Title: Plant POP - 6 pages for Ecology Inspection

Engineering change notice 12/20/93 ECN 60213 Title"211-T Valve Replacement."

Work Change Notice Title, "211-T Chem Transfer line valve." Document Number
2T-93-00747/W

1. ECN 60210

ECN #602137 P. 3/4

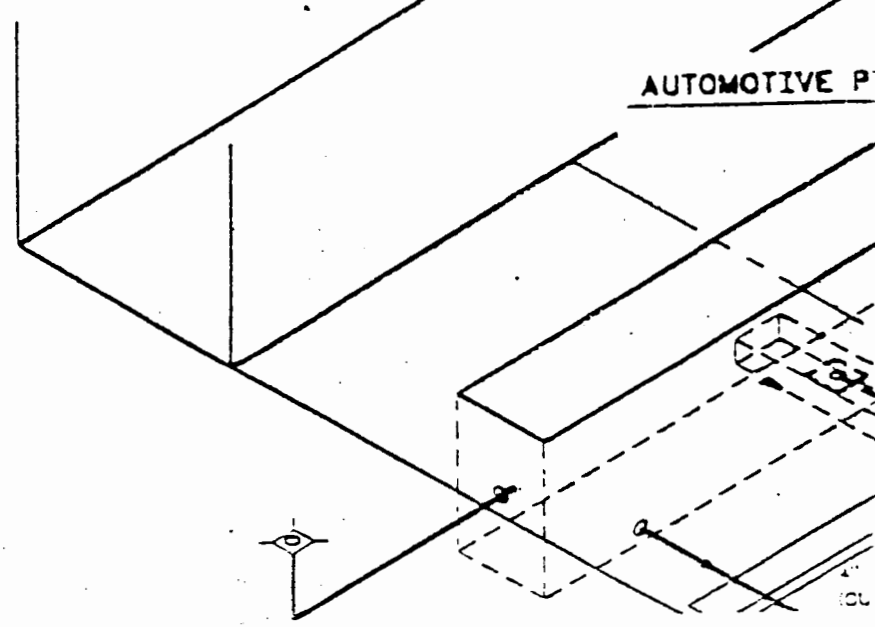
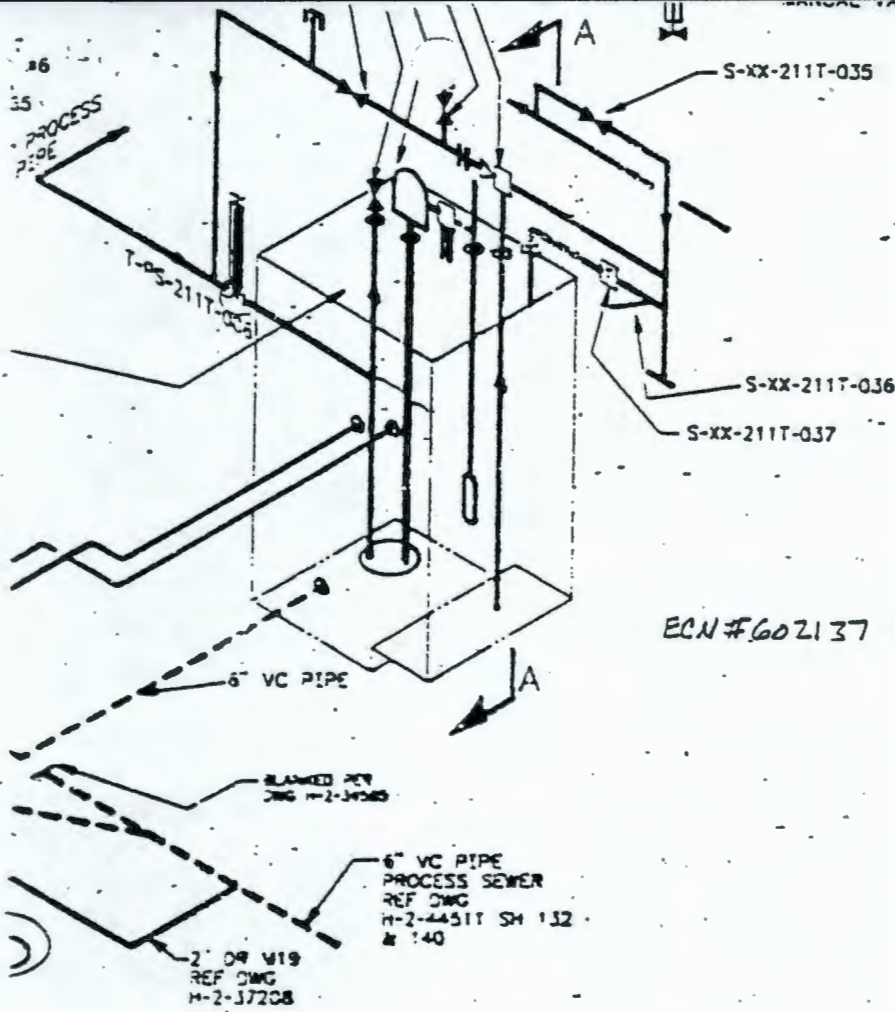
12. Description of Change
 ADDED NOTE NEXT TO VALVE T-PS-211T-006 PER PAGE 3 OF THIS ECN. ADDED NOTE PERTAINING TO VALVE T-PS-211T-006 PER PAGE 4 OF THIS ECN.

13b. Justification Details
 CLARIFICATION OF VALVE TYPE, SIZE AND MATERIAL NECESSARY.

3. VALVE T-PS-211T-006 TO BE A 2" FLANGED S.S. BALL VALVE, 1501B.

ADD NOTE
